RESPONSE TO REQUEST FOR ADDITIONAL INFORMATION

APR1400 Design Certification

Docket No. 52-046

RAI No.: 153-8070
SRP Section: 10.04.03 – Turbine Gland Sealing System
Application Section: 10.4.3
Date of RAI Issue: 08/13/2015

Figure 10.4.3-1 Turbine Gland Sealing System Flow Diagram

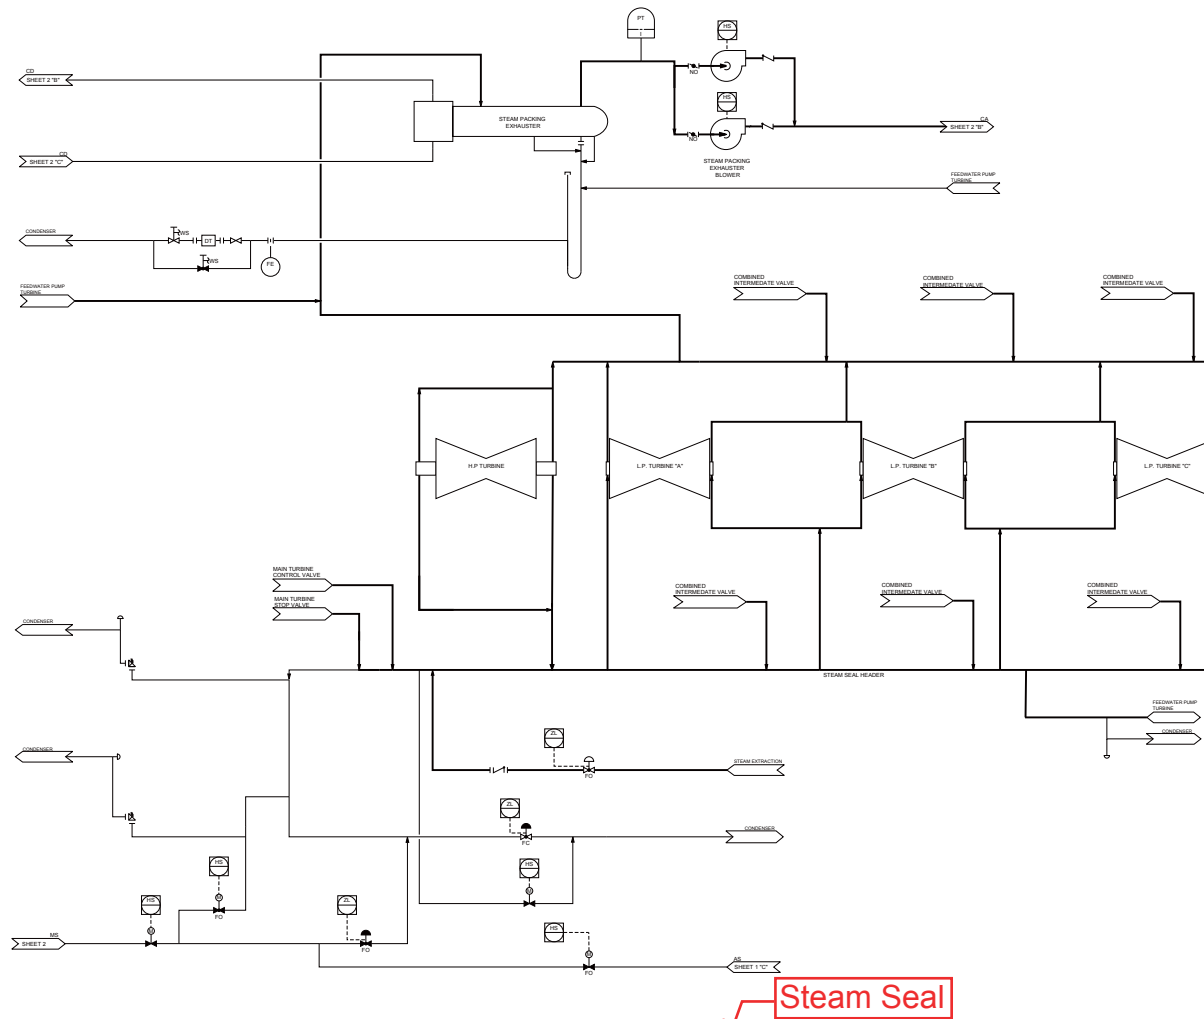
The staff finds the applicant using two terms: turbine gland sealing system (TGSS) and turbine steamseal system (TSSS) throughout DCD Chapter 10. It appears these two names are for the same system.

The applicant is requested to clarify the differences between turbine gland sealing steam, TGSS, and turbine steam-seal system, TSSS. The DCD should be modified accordingly.

Turbine gland sealing system and turbine steal seal system are the same system. “Turbine gland sealing system” described on DCD Tier 2 will be revised to “turbine steam seal system” as indicated on the attached markups.

DCD Tier 2, descriptions, tables and figures will be revised as indicated on the attached markups.
